REGIONAL DISTRICT OF NANAIMO

REQUEST FOR TENDER No. 20-038

Gabriola Island Village Way Path Construction Project

Addendum 2 (15 Pages)
Issued: June 30, 2020

DRAWING TITLE: NORTH ROAD STATION 1+000 – 1+185

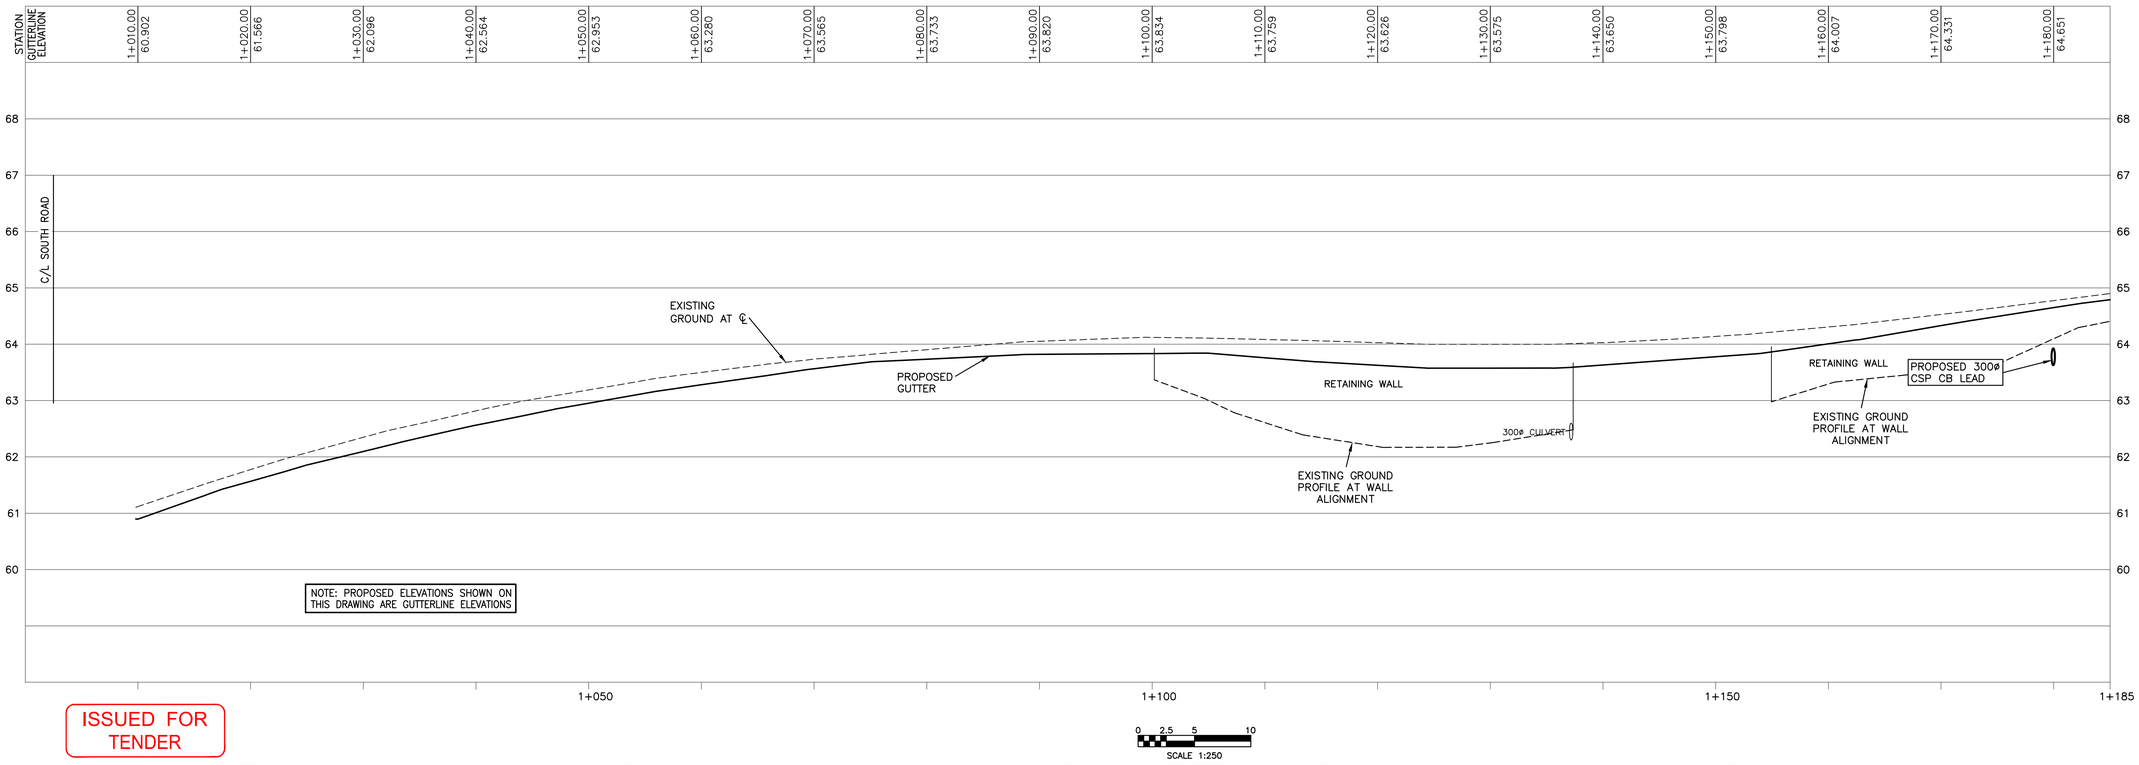
Q: Flow Control Manhole detail shows an existing CB with a Storm Sewer. Please provide size for the existing storm sewer.
A: CB is proposed. Existing storm sewer size is unknown and is to be determined by Contractor as per note on drawing 0110-017-02.

DETAIL– WELD PLATE FOR RAILING POST
NTS

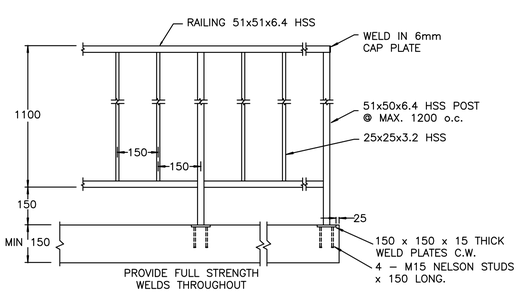
Q: Questions in regards to the railing:

- Finished coating - Paint, Galvanized, Etc.
- More detail on style, design of handrail, picket material
- Connection plate detail/type
- Require CWB welding certification
- Field connection detail, weld together or bolt/floating

Q: Can you please provide a detail drawing of the Hand Rail, including imbeds and railing.
A: See revised Design Drawings.

A: See revised Design Drawings.

4. ALL STEEL IS TO BE HOT DIPPED GALVANIZED WITH BLACK POWDER COATING.

FLOW CONTROL MANHOLE DETAIL
N.T.S.

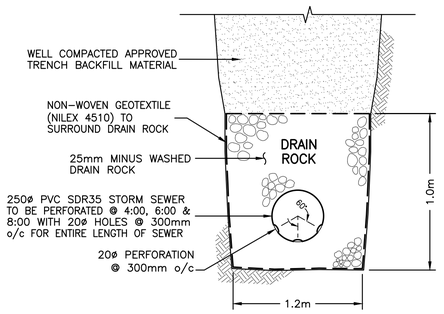
Q: Flow Control Manhole detail does not provide dimension of the manhole. Please provide.
A: 1200mm diameter.

Q: Please specify the diameter of the Flow Control Manhole.
A: 1200mm diameter.

EXFILTRATION TRENCH DETAIL
N.T.S.

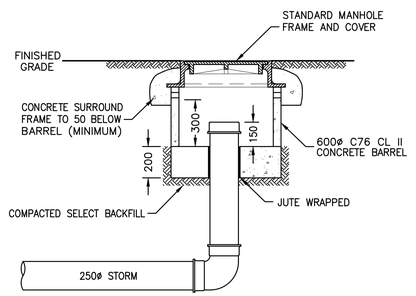
Q: Does the 250dia. perforated pipe require 3 holes at the bottom, as displayed in the detail, or can we use a standard perforated pipe, with 1 hole?
A: As per detail.
